INNER WEST COUNCIL

DEVELOPMENT ASSESSMENT REPORT

Application No.	10.2017.264.1
Address	27 Stanton Road, Haberfield
Proposal	Alterations and additions to an existing dwelling house, including the construction of a new swimming pool and attic space.
Date of Lodgement	20/12/2017
Applicant	Filmer Architects
Owner	Dr S L Burke
Number of Submissions	Two (2)
Value of works	\$ 1,189,650
Reason for determination at Planning Panel	Clause 4.6 variations for maximum height of building and minimum landscaped area.
Main Issues	<ul style="list-style-type: none"> • Height of building • Landscaping • Privacy • Noise
Recommendation	Consent subject to conditions

Picture 2 – Location of proposed height variation.

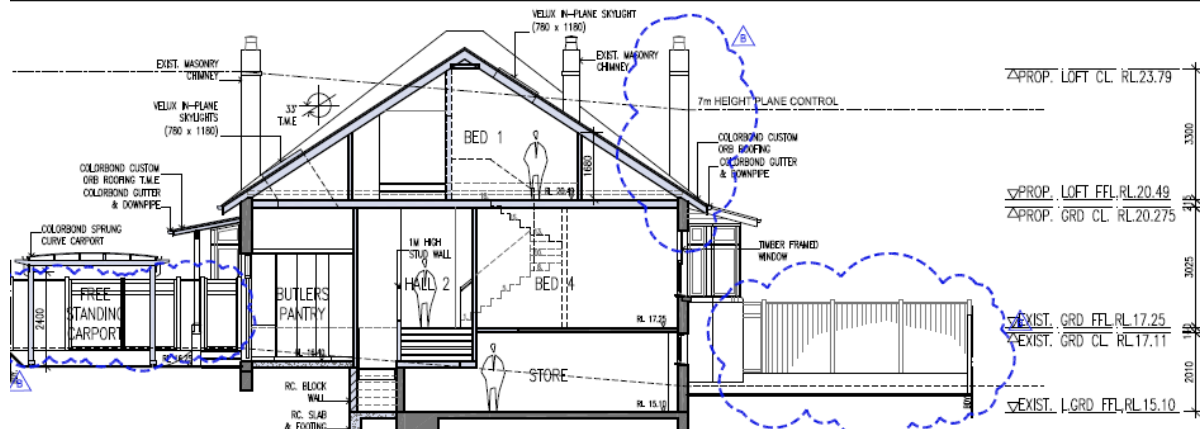
Picture 2 below outlines the extent and location of the height variation in section.

The development has a maximum building height of 8.2 metres and thereby exceeds the maximum height of 7.0m of the development standard prescribed under Clause 4.3 of ALEP 2013.

The applicant seeks to vary the maximum height of building standard by 1.2m or 17.1%.

In this instance the proposed 1.2m height variation relates directly to a section of the roof approximately 6m in length, restricted to the centre of the site and setback roughly 10m from the southern side boundary and 11m from the northern side boundary. Acceptance of the variation with the proposed side setbacks of 10m and 11m is expected to result in minimal loss of sky exposure/ daylight access for neighbouring sites to the sides. The proposal continues the established height enjoyed by the original dwelling, ensuring the retention of building height transitions between buildings, while also ensuring the height variation will not be out of character for the locality. The proposed side and rear setbacks surrounding the portion of the height variation ensure satisfactory solar access to neighbouring buildings and public areas. The proposed development is considered to be consistent with both the objectives of the zone and the objectives of the development standard.

The justification provided in the applicant's written request is considered well founded and worthy of support. Considering the above justification, strict compliance with the development standard is considered unreasonable and unnecessary given the circumstances of the site.

Picture 3 – Existing and proposed landscaped areas.

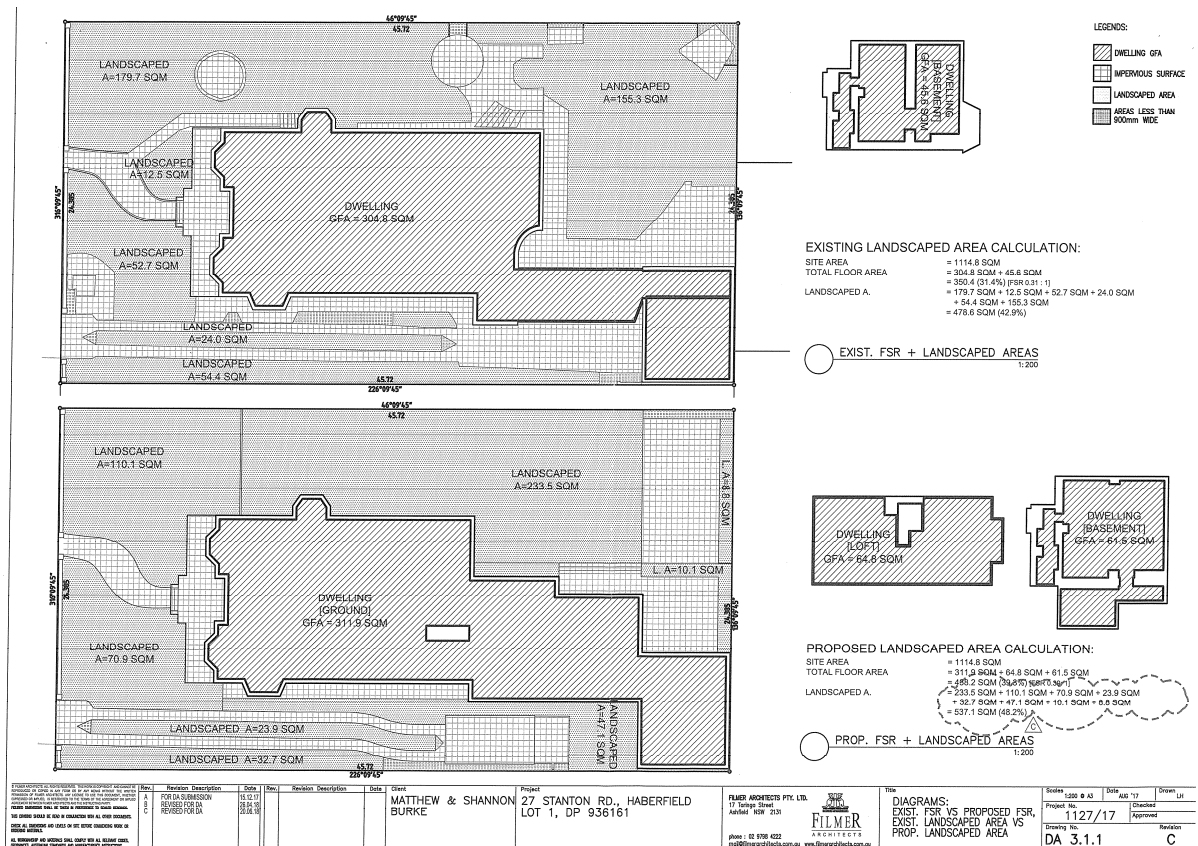
Picture 3 below provides a comparison of the existing landscaped areas vs the proposed landscaped areas, outlining where on the site the applicant proposes to provide an increase to the landscaping.

The proposed development results in a landscaped area of 48.2% of the site area which is a shortfall of 20.3m² a 3.7% variation to the development standard.

The proposed 3.7% variation from the required 50% landscaped area is a minor variation from the development standard and the proposal increases on-site landscaped area by 58.7m² is a significant improvement to on-site landscaping and substantial improvement to the overall garden suburb attributes. The proposal maintains a single storey dwelling appearance. The proposed development is considered to be consistent with both the objectives of the zone and the objectives of the development standard.

The justification provided in the applicant's written request is considered well founded and worthy of support. Considering the above justification, strict compliance with the development standard is considered unreasonable and unnecessary given the circumstances of the site.
